Turbo HD DVR V3.5.10 build170518 Release Notes (2017-05-24)

Firmware Version:	V3.5.10 build170518
	SDK Version:	V5.2.7.30 build20170428
Firmware	Play Library (PlayCtrl.dll)	7.3.2.0
Basic Information	player	4.8mini
	Web version	V4.0.1 build 170419
	Client version	V2.5.8.101 build20170426

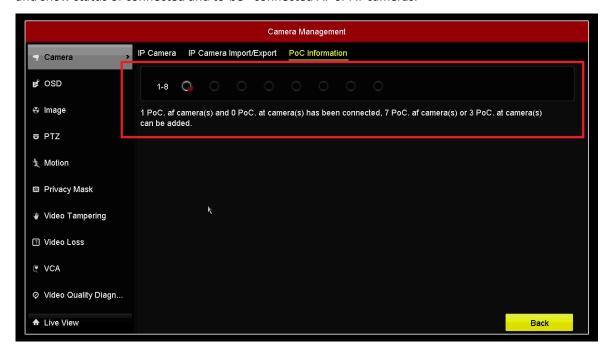
- i. Compatible with all functions on version 3.5.0, refer to 3.5.0 release notes for more details.
- ii. Newly release K series DVR
 - 1) Release new models: DS-7204HQHI-K1、DS-7208HQHI-K1、DS-7208HQHI-K2、DS-7216HQHI-K1、DS-7216HQHI-K2、DS-7204HQHI-K1/P、DS-7208HQHI-K2/P、DS-7204HUHI-K1、DS-7204HUHI-K2。
 - 2) Newly support H265/H265+ codec technology, which is more efficient than H264 in video coding compression.
 - 3) For HQHI-K series, support access of **3MP TVI** cameras. 3 MP signal input is only available for channel 1 of DS-7204HQHI-K1(/P), channel 1/2 of DS-7208HQHI-K2(/P), and for channel 1/2/3/4 of DS-7216HQHI-K2.
 - 4) For HUHI-K series, Support encoding resolution and frame rate: 5MP@ 12fps, 4MP @15fps, 3MP@ 18fps, 1080P@real time.

vii. IPC access:

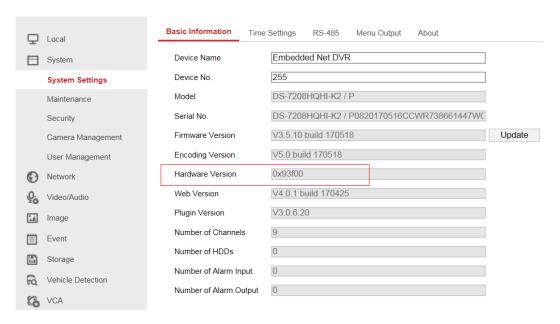
- 1. Up to 2-ch 6MP IPCs access for 7204/7208/16HUHI-K
- 2. Up to 1-ch 4MP IPC access for 7204HQHI-K
- 3. Up to 2-ch 4MP IPCs access for 7208/7216HQHI-K
- viii. Newly support Hardware Version in webpage of device.
